**ZONING AMENDMENT,  
PLANNED UNIT DEVELOPMENT &  
SUBDIVISION STAFF REPORT****Date: December 18, 2014**

<b><u>NAME</u></b>	iSam North America Corp
<b><u>SUBDIVISION NAME</u></b>	Bel Air Boulevard Subdivision, iSam Addition
<b><u>LOCATION</u></b>	500 Broadcast Drive (North terminus of Broadcast Drive)
<b><u>CITY COUNCIL DISTRICT</u></b>	District 5
<b><u>CURRENT ZONING</u></b>	B-1, Buffer Business District, and B-3, Community Business District
<b><u>PROPOSED ZONING</u></b>	B-1, Buffer Business District
<b><u>REASON FOR REZONING</u></b>	To eliminate split zoning in a proposed Subdivision.
<b><u>AREA OF PROPERTY</u></b>	1 Lot / 4.8± Acres
<b><u>CONTEMPLATED USE</u></b>	<p>Subdivision approval to create 1 legal lot of record, Planned Unit Development Approval to allow shared access between two building sites, and Rezoning from B-1, Buffer Business District, and B-3, Community Business District, to B-1, Buffer Business District to eliminate split zoning in a proposed Subdivision.</p> <p><b>It should be noted, however, that any use permitted in the proposed district would be allowed at this location if the zoning is changed. Furthermore, the Planning Commission may consider zoning class

## DETAIL SITE PLAN

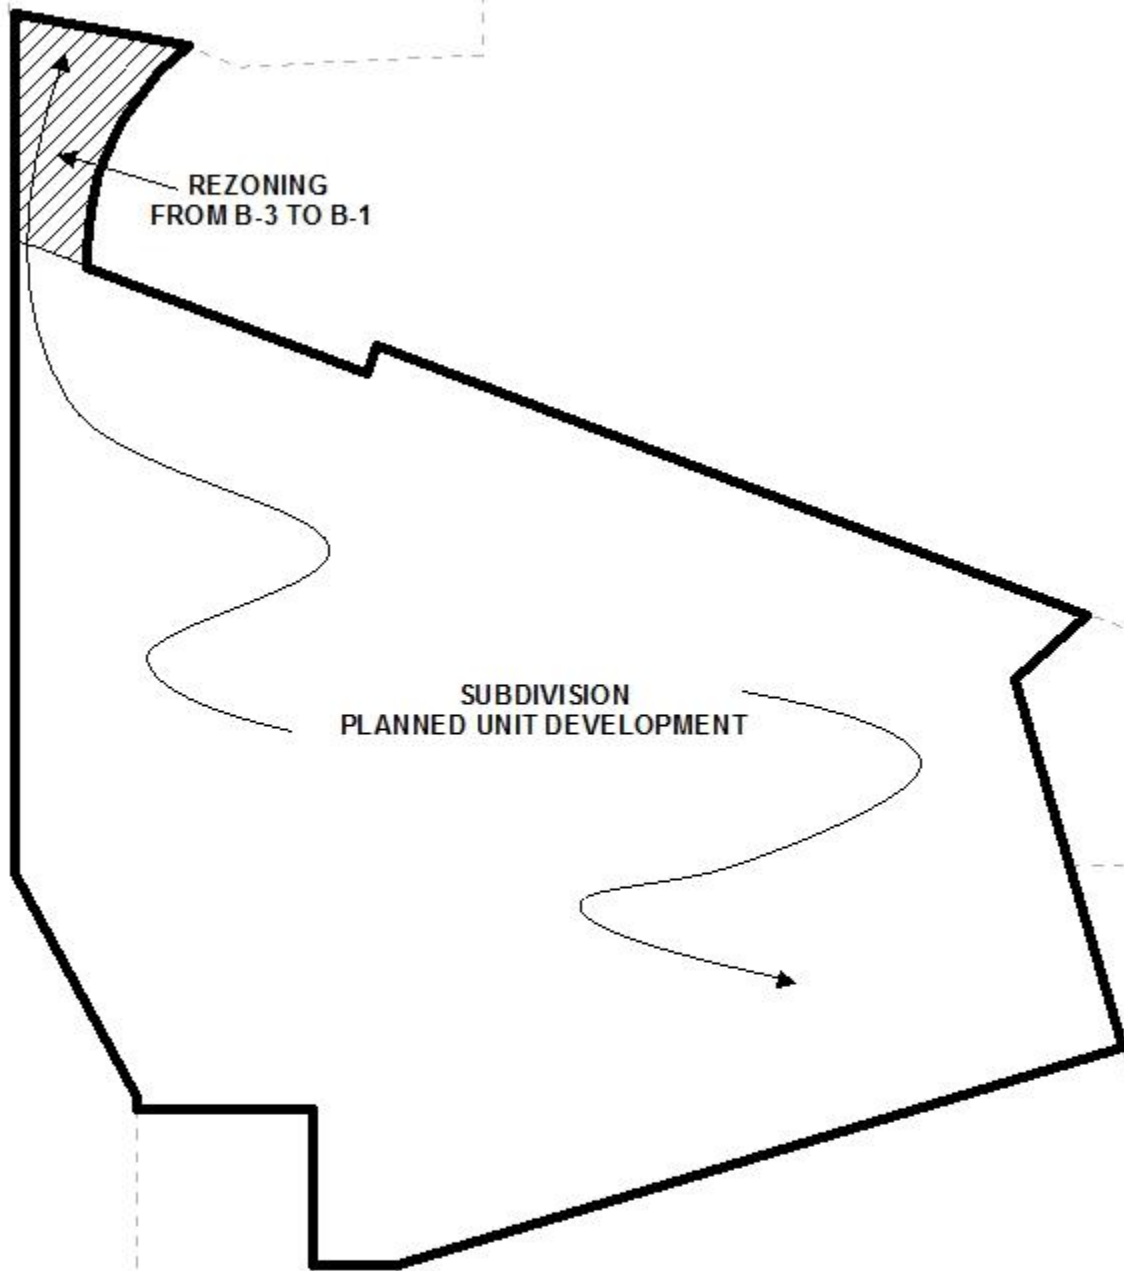
As the site is proposed to share access with the developed office building site adjacent to the Southwest corner, the PUD is required to allow such. All access to the subject site is proposed via the street stub at the North terminus of Broadcast Drive, and the two sites would share the proposed drive onto Broadcast Drive. The adjacent site already has access to the applicant's site onto an existing driveway to the street stub to Broadcast Drive. For some reason, no PUD was required prior to the development of that site in 2006 to allow the shared access. Both sites would have autonomous parking and sufficient spaces are indicated for such. However, the calculations for the proposed development should be rounded up to 28 required spaces instead of 27 as indicated.

No public sidewalk is indicated along the street frontage. However, the frontage is strictly a street stub terminus which is paved within its entire right-of-way width; therefore, the requirement of a public sidewalk would be impracticable. An on-site review of the adjacent developed site indicates an exposed dumpster within the North parking lot. The site plan should be revised to indicate compliance for this dumpster. Also, the site plan does not indicate any dumpster for the applicant's site. The site plan should either be revised to indicate a compliant dumpster enclosure for that site or a note should be placed on the site plan stating that no dumpster will be utilized and refuse collection will be either curbside or by private can collection services. It should be noted that any later addition of a dumpster will require compliance.

The site is adjacent to residential uses and zoning along its East side. As the site is moderately wooded in that area, the provision of a 6' privacy fence buffer would not be required if a 25' natural vegetative buffer is maintained. However, a note should be required on the site plan stating that if the wooded area adjacent to the residential area should be removed for any reason, a 6' high wooden privacy fence buffer would be required to be constructed.

No tree planting plan was provided with the site plan. Full tree and landscaping compliance will be required, and any existing trees which are kept may be used as credit towards compliance.

- 1) revision of the parking calculations to indicate 28 required parking spaces instead of 27;
- 2) revision of the site plan to indicate a compliant dumpster enclosure and pad for the developed adjacent site;

- 3) revision of the site plan to indicate a complaint dumpster and pad for the proposed development, or the placement of a note on the site plan stating that no dumpster will be utilized and refuse collection will either be curb-side or by private can collection services;

- 4) revision of the site plan to label the site area in both square feet and acres, or the furnishing of a table on the site plan providing the same information;

- 5) placement of a note on the site plan stating that a 25' natural vegetative buffer is to be maintained along the East side of the site, or if the wooded area along that side adjacent to residential property should be removed for any reason, a 6' high wooden privacy fence buffer will be required to be constructed;

- 6) revision of the site plan to illustrate the 25' minimum building setback line as measured from the North terminus of Broadcast Drive;
- 7) placement of a note on the site plan stating that the site is limited to the existing curb cut to Broadcast Drive, with the size, location and design to be approved by Traffic Engineering and conform to AASHTO standards;
